# **Citizens Working Group Recommendations to the Joint Cities Working Team on the Stevens Creek Trail Feasibility Study**

STEVENS CREEK TRAIL FEASIBILITY STUDY  
CITIZENS WORKING GROUP PREFERRED ALIGNMENT

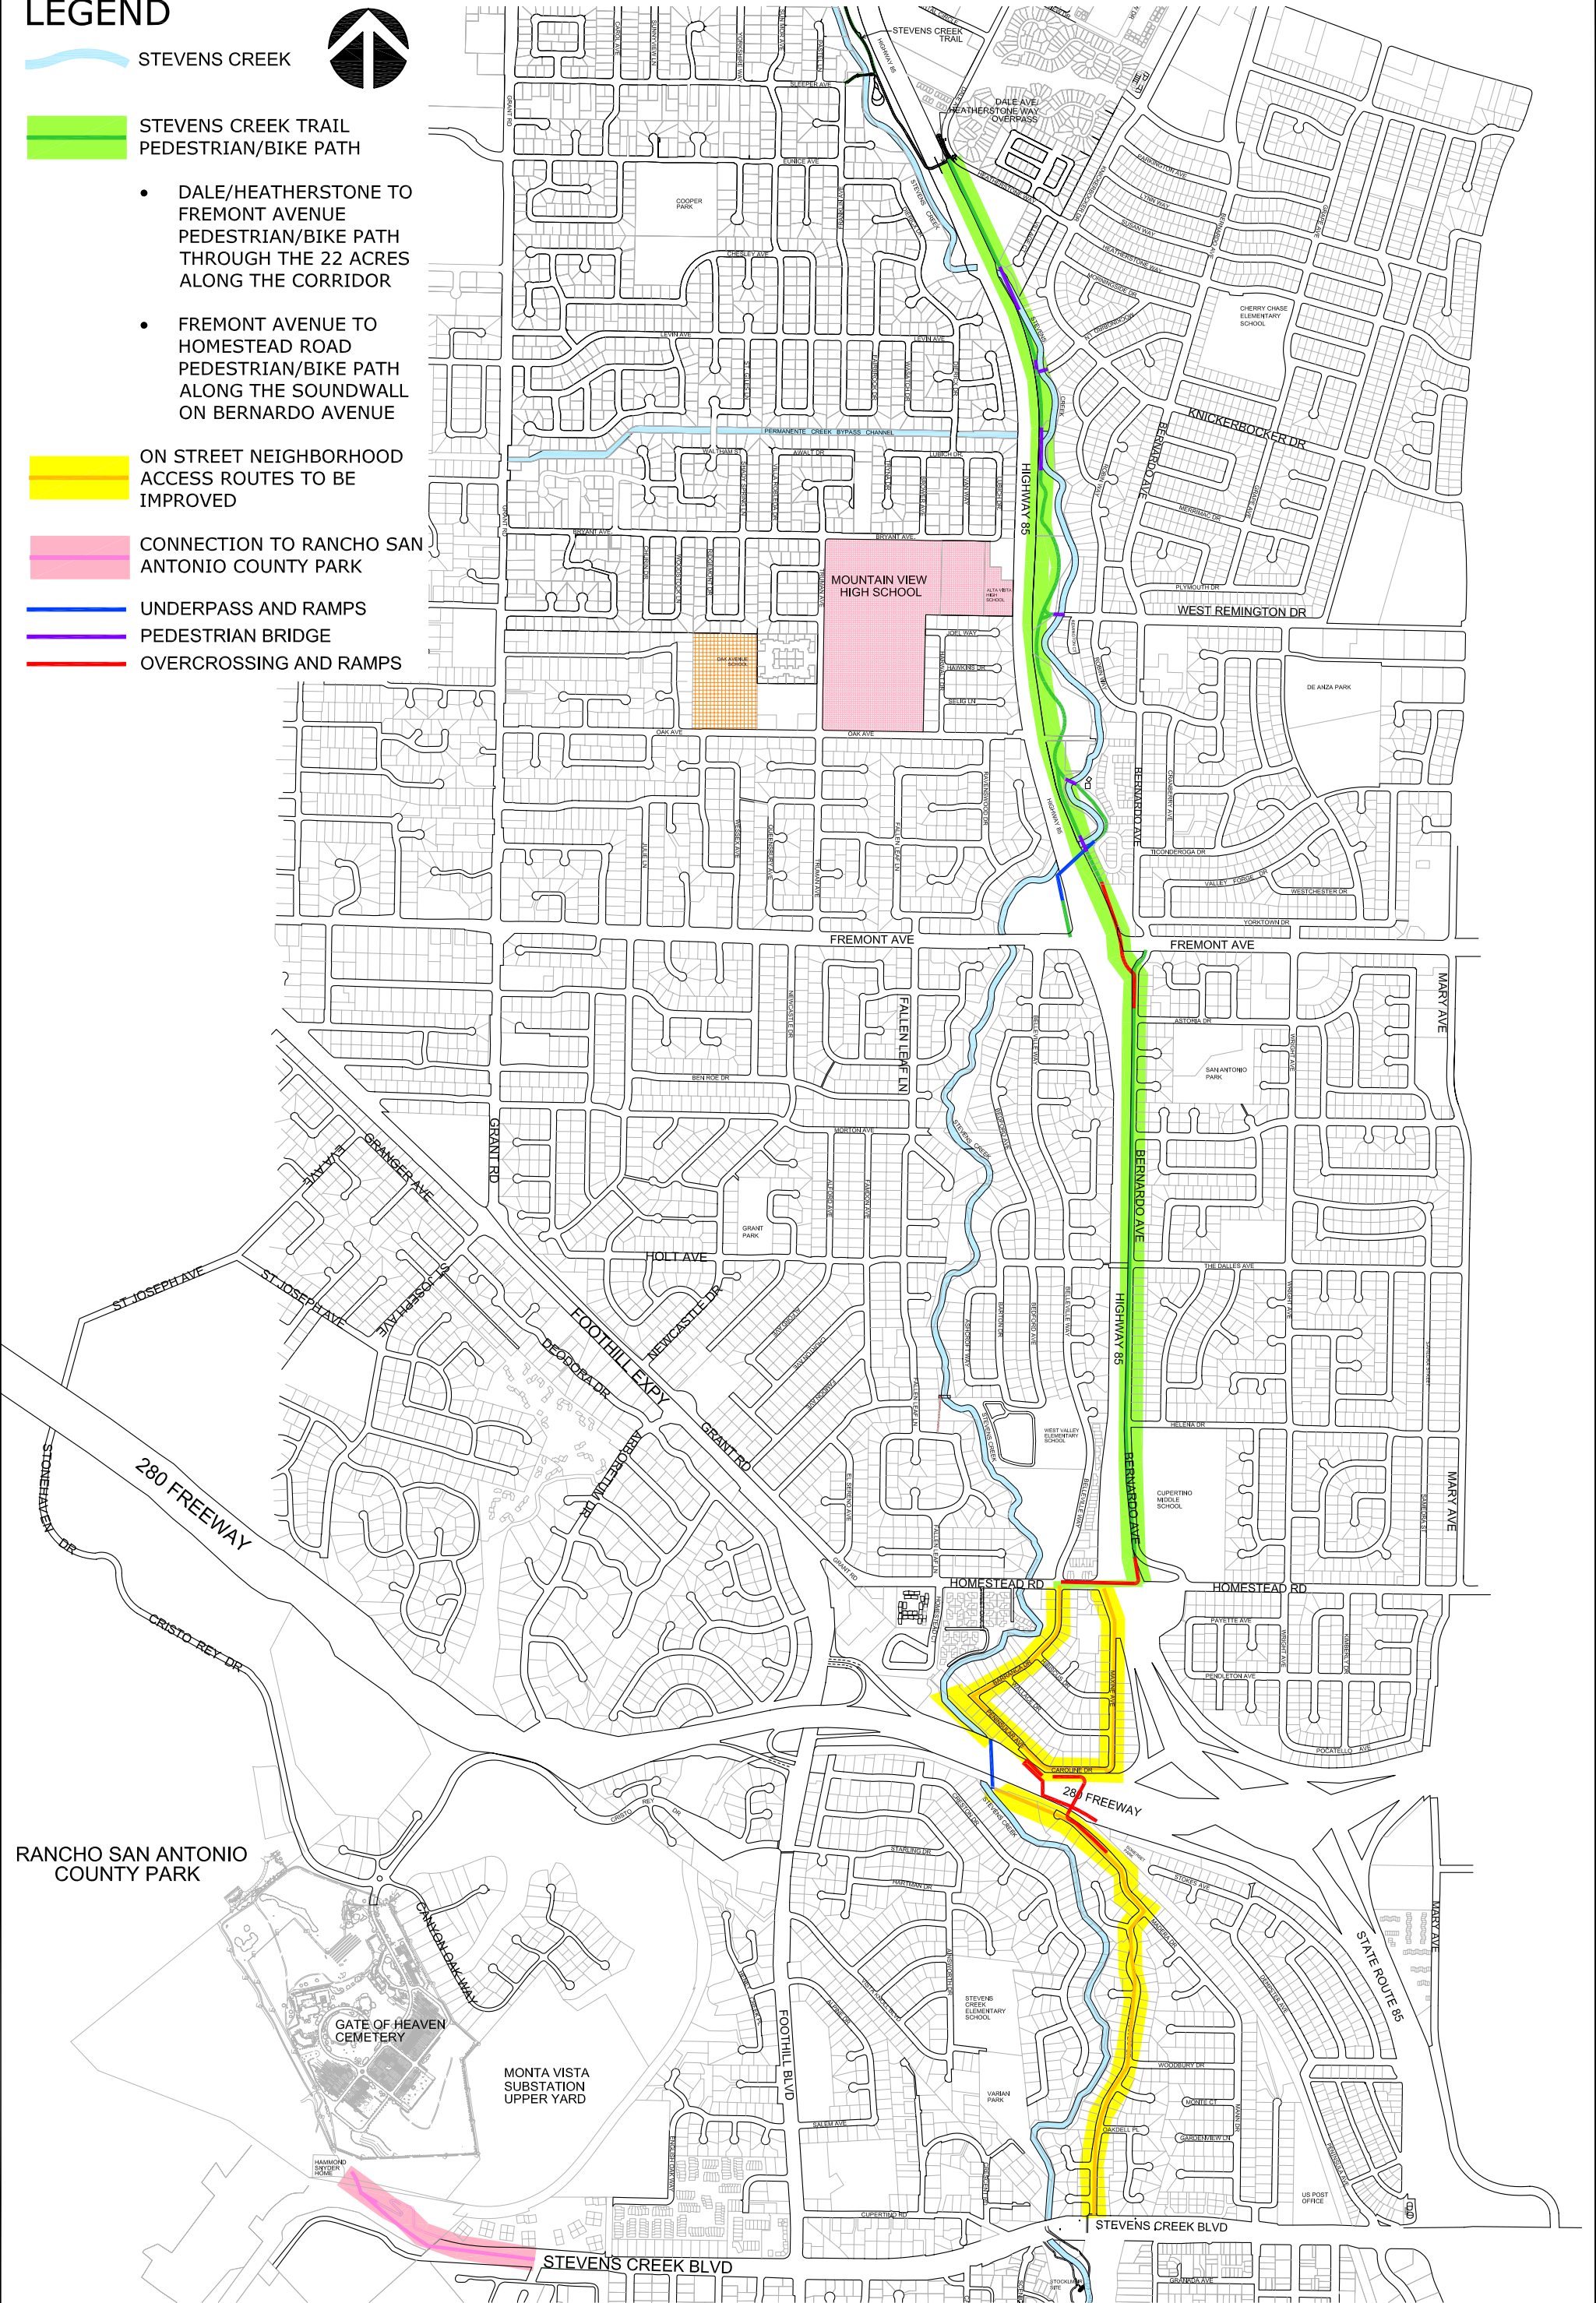
- The preferred alignment and top priority is to extend the Stevens Creek Trail through the 22 acres of open space along State Route 85 from Dale/Heatherstone to Fremont Avenue. The trail should incorporate habitat enhancements and the 22 acres along the creek corridor should be managed as passive open space.
- Develop the project in phases, as needed, to construct as soon as possible. Suggested phases include Dale/Heatherstone to Remington and Remington to Fremont Avenue.
- Include a neighborhood access point at Remington Avenue.
- Continue to explore the potential for an overcrossing over Highway 85 to provide a connection to Mountain View High School, which would provide

- The preferred crossing of Fremont Avenue is a pedestrian/bike overcrossing to Bernardo Avenue to continue the separated pedestrian/bike path.
- A second connection to Fremont Avenue is also recommended via a trail underpass beneath State Route 85 connecting to Fremont Avenue west of the Highway 85 interchange adjacent to the southbound off-ramp. A preferred alternative to make this connection is to pursue a trail easement along the creek through the parking lot located at 1195 W. Fremont Avenue (current Stanford medical office).
- When the Fremont Avenue bridge over Stevens Creek is replaced in the future, consider a trail underpass to facilitate pedestrian and bicycle crossings of Fremont Avenue and provide an access point to the trail.

- If a pedestrian overcrossing at Fremont Avenue is considered feasible, the preferred alignment to extend the Stevens Creek Trail is a separated off-street pedestrian/bike path along the soundwall on Bernardo Avenue. This pedestrian/bike path would continue the experience of the trail by providing a route free from automobile traffic.

- The feasibility study indicates that a road reconfiguration of Bernardo is necessary to support the off-street pedestrian/bike path. Conduct traffic and parking studies to determine the feasibility of either one-way traffic or two-way traffic with loss of parking.

- If a separated pedestrian/bike path were not feasible on Bernardo, the second choice would be to modestly enhance Bernardo, Belleville and Fallen Leaf streets with bicycle safety improvements and wayfinding signage to the trail. None of these on-street routes would be designated as the Stevens Creek Trail. Even if the off-street route on Bernardo is considered feasible, evaluate bicycle safety improvements that could be made with modest improvements to Belleville and Fallen Leaf.

- Connect the pedestrian/bike path on Bernardo to the pedestrian/bike path on the north side of Homestead Road in Los Altos. The Homestead Road path currently extends from Stevens Creek west to El Sereno Avenue near the Grant Road/Foothill Expressway intersection. Continue to explore either a) widening the existing Homestead Road Bridge over State Route 85 or b) placing a new pedestrian/bike bridge parallel and just to the north of the Homestead Road bridge and making path improvements in Sunnyvale west from State Route 85 interchange to Stevens Creek to provide for a continuous off-street path. Extension of the Homestead Road path could proceed as a

- A new grade-separated crossing of Interstate 280 is recommended to provide access to the Stevens Creek Trail on a direct route along low-volume, low-speed streets. The potential grade-separated crossing alternatives in order of preference include:

- i. The preferred crossing is a trail underpass beneath Interstate 280 using one of the existing tunnels that convey the Stevens Creek flows to San Francisco Bay. This option is potentially technically feasible but was previously not supported by Caltrans. The use of one of the tunnels should continue to be pursued as a long-term solution to extending the trail south. The tunnel route would connect Barranca Drive to Madera Drive. The trail would use Madera Drive to Phar Lap Drive to access Stevens Creek Blvd., where it would connect to the existing trail in Cupertino.

- ii. An alternate choice is a pedestrian overcrossing that spans both Interstate 280 and the UPRR tracks connecting Peninsular Avenue to Madera Drive.

- iii. Another option to consider if the previous two alternatives for crossing I-280 were considered infeasible is a pedestrian overcrossing that spans only Interstate 280 connecting Caroline Drive to Somerset Square Park located off Stokes Avenue.

- A pedestrian/bike path that extends along the north side of Stevens Creek Boulevard west from Stonebridge to undeveloped open space land behind the Gate of Heaven Cemetery is recommended to provide access to Rancho San Antonio County Park. This alignment would include a pedestrian/bike bridge over the UPRR tracks to provide a connection to the Hammond-Snyder Loop Trail in Rancho San Antonio County Park. This route is viewed as an important recreational amenity for the community and could be developed as a stand-alone project.
- A trail staging area with parking, restrooms and signage is recommended. The additional parking area would provide a more convenient access into Rancho San Antonio County Park and would also help reduce parking demand at the busy Rancho San Antonio parking lots.
